**FINDINGS AND RECOMMENDATION
OFFICE OF PLANNING AND ZONING
ANNE ARUNDEL COUNTY, MARYLAND**

CASE NUMBER: 2025-0180-V

REQUEST

SITE DEVELOPMENT PLAN

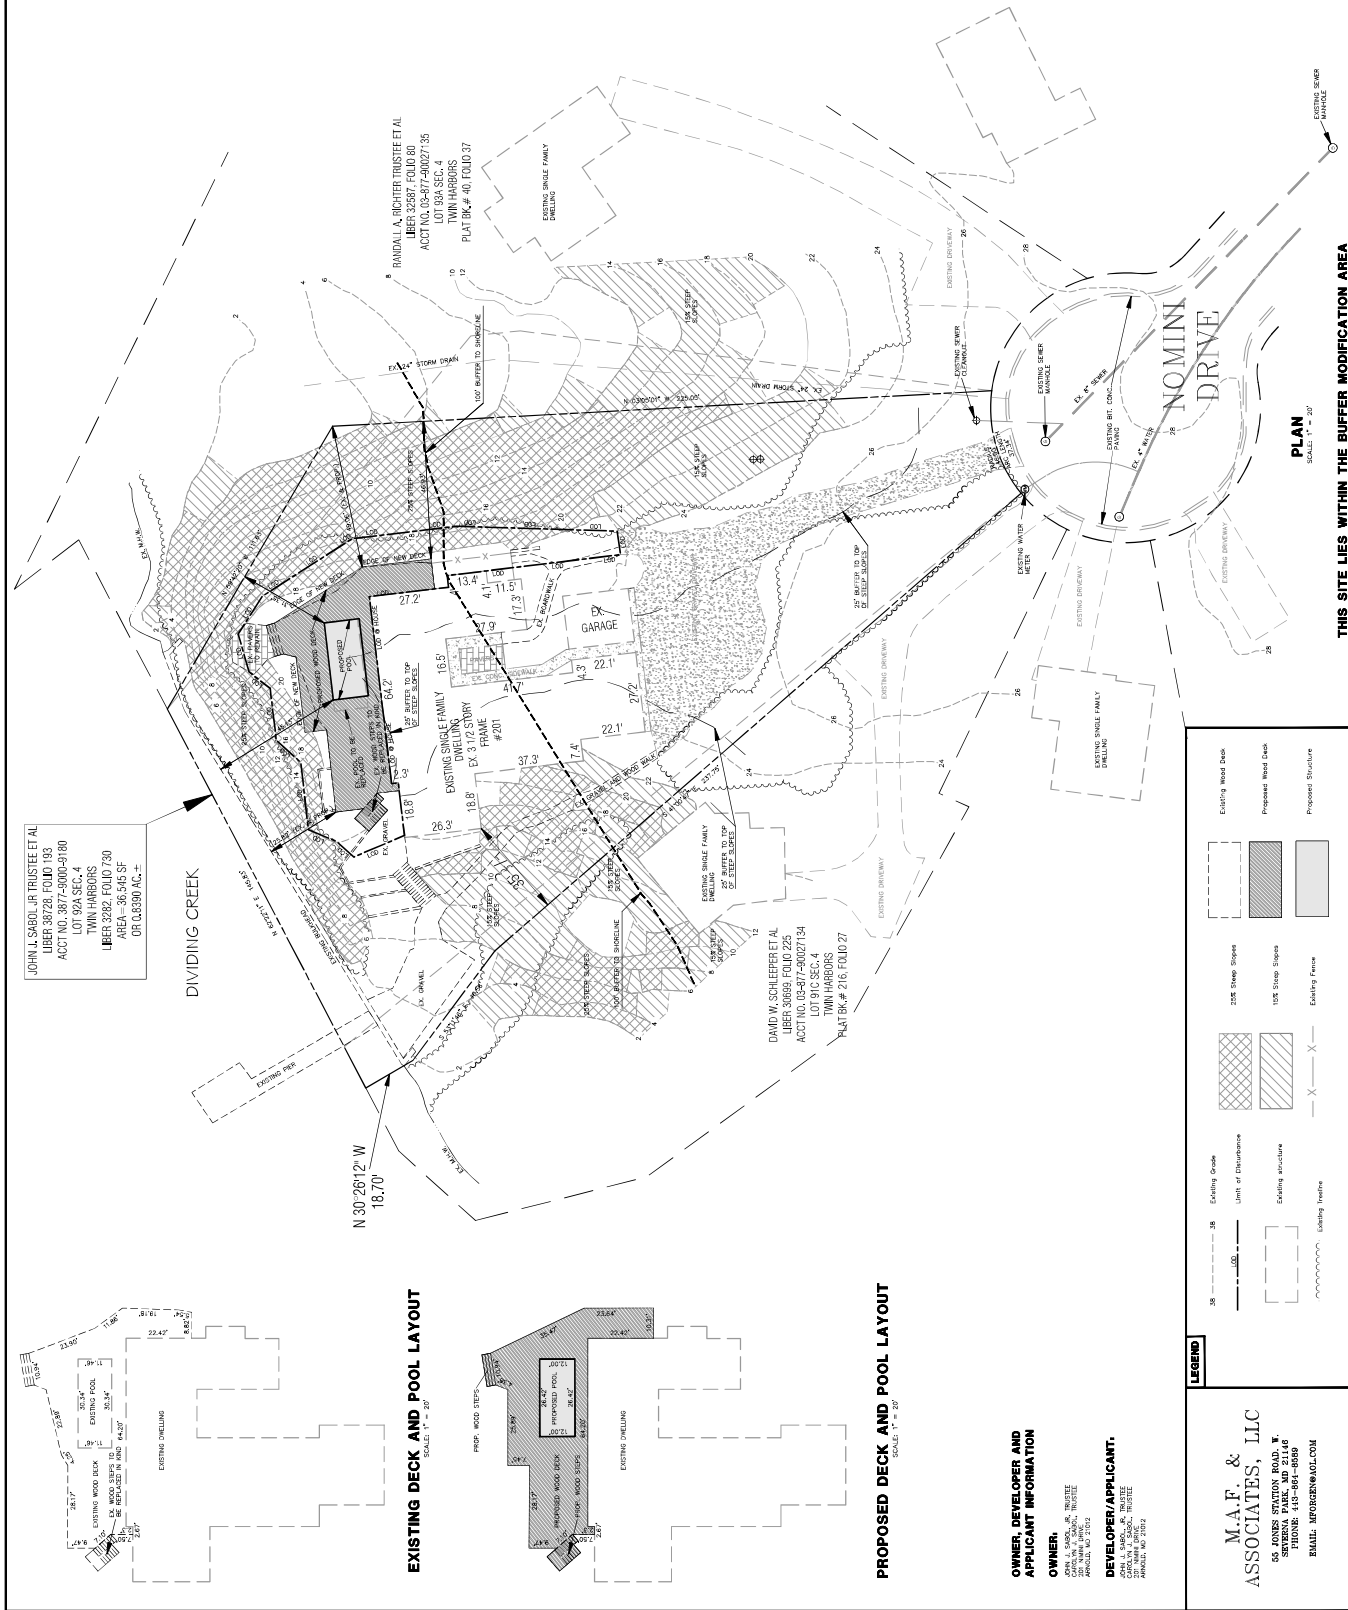
Comments from the Critical Area Team at the pre-file were no objection to the repair/replacement of the existing deck and pool, however, they could not support the expansion of any of the proposed dimensions for the replacement. This Office notes that there were slight changes made to the site plan between the pre-file and the variance application that related to retaining walls to remain, gravel to be removed, and paver to be removed. Coverage calculations were adjusted. The proposed configuration of the pool, deck and stairs did not change.

The **Development Division (Critical Area Team)** commented again that there is no objection to the repair/replacement of the existing deck and pool, however, this office cannot support the expansion of any of the proposed dimensions for the replacement. Safety concerns should be addressed by the installation of an appropriate railing or the relocation or reduction of the pool in order to provide a wider walking area not by expanding further into the steep slopes. The 10% lot coverage reduction requirement will be addressed at permit.

The **State Critical Area Commission** commented that this project proposes to replace and reconfigure outdoor amenity space, including the pool and wooden decking. The applicants are seeking a variance to place lot coverage nearer to the shoreline than the closest façade of the existing principal structure and to disturb steep slopes. The existing site improvements exceed the lot coverage limits by 5,955 square feet, and per Anne Arundel County Code §17-8-402, the applicant is reducing lot coverage by 10% of the exceedance. Although the proposed project includes this reduction in lot coverage, the lot will remain nonconforming as the lot coverage limits will still be exceeded by 5,359 square feet. The current proposal includes reconfiguring the wooden decking to further disturb slopes than what currently exists onsite. This office would like to note that since the proposal includes the reconfiguration of the outdoor amenity space, the applicants have the opportunity to minimize impacts to steep slopes in their site design for these accessory structures.

warranted for new lot coverage due to the change in overall dimensions of the new pool, the granting of the steep slope variance based on the proposed location would confer on the applicant a special privilege that would be denied by COMAR, Title 27.

Regarding the front setback variance, the location of the closest point of the deck will remain at 25.82 feet from the bulkhead. The front setback for the R2 District changed from 30 feet to 25 feet with the effective date of Bill 72-24 on July 1, 2025. The variance is necessary because the permit was submitted prior to the effective date of the Bill. This variance is considered to be the minimum necessary.

Regarding the variance for new lot coverage nearer to the shoreline, the existing pool is 11.46 feet wide and 30.34 feet long with 347.7 square feet in area; the proposed pool is 12 feet wide, 26.42 feet long with 317 square feet in area. The proposed pool creates 14.3 square feet of new lot coverage. While any new lot coverage in the BMA that is between the house and the shoreline requires a variance, the new coverage is being created between the existing pool and the house and the location of the north side of the pool is remaining the same. Because the pool length is being shortened, the overall lot coverage of the pool is actually being lessened by approximately 40 square feet. The reconfiguration of the pool creates a minimal amount of new lot coverage nearer to the shoreline than the closest facade of the existing principal structure and the new pool holds the location of the closest line of the pool from the water therefore, this request can be considered to be the minimum necessary to afford relief. This Office has no objection to this variance.

large deck surrounding a pool, replacement of the pool, and a set of steps within the BMA. This Office recognizes that there are edges of the existing deck that are irregular and squaring off or smoothing out may increase safety, but there are other configurations that would honor the steep slopes. Specifically, the proposed 8.82-foot width of the deck on the east side could have been reduced to a minimized walkway if the east side access is required to wrap around to the dwelling's north side due to an access door. The edge of the new deck just to the north of the proposed pool and on the east side of the pool could be designed to be out of the slopes and still provide an adequate walkway around the pool. Therefore, the variance requests for the deck to be expanded onto the steep slopes cannot be considered to be the minimum necessary to afford relief.

Critical Area Team: There is no objection to the repair/replacement of the existing deck and pool however cannot support the expansion of any of the proposed dimensions for the replacement.

The 10% lot coverage reduction requirement will be addressed at permit. The calculations depicted on this plan do not reflect compliance. Approval will not be granted until this requirement has been addressed.

Zoning Administration Section: This proposal cannot be considered the minimum required given that a replacement in kind is possible without actual disturbance to steep slopes.

With regard to the standards by which a variance may be granted as set forth in § 18-16-305, under the County Code, the Office of Planning and Zoning recommends **approval** of the critical area variance to § 17-8-702 (b) to allow 14.3 square feet of new lot coverage nearer to the shoreline than the closest facade of the existing principal structure for construction of the proposed pool, and **approval** of the zoning variance to § 18-4-601 to allow the deck to be constructed 25.82 feet from the front lot line. However, the Office of Planning and Zoning recommends **denial** of the critical area variance request to § 17-8-201(a) to allow disturbance to slopes of 15% or greater to expand the deck as shown on the site plan submitted.

Our response: The small expansion of the deck is for safety purposes. The existing deck has some odd angle down the side of the house that makes pedestrian traffic difficult and a bit unsafe. Likewise, the small expansion on the waterfront side of the pool is for the same safety reason. The existing deck is angles close to the corner of the existing pool that makes it unsafe to walk around the pool in this location. The new

Our response: The plan has been revised to reflect the 10% lot coverage reduction requirement. This required the limit of disturbance to be adjusted and therefore the variance request has been slightly adjusted.

Our response: The small expansion of the deck is for safety purposes. The existing deck has some odd angle down the side of the house that makes pedestrian traffic difficult and a bit unsafe. Likewise, the small expansion on the waterfront side of the pool is for the same safety reason. The existing deck is angles close to the corner of the existing pool that makes it unsafe to walk around the pool in this location. The new configuration makes the pool a little smaller than the existing pool as well as making the area much safer to walk around being so close to the top of slope. We feel with the safety issues considered and the reduction in pool size, this plan demonstrates minimum relief and feel this request should be supported.
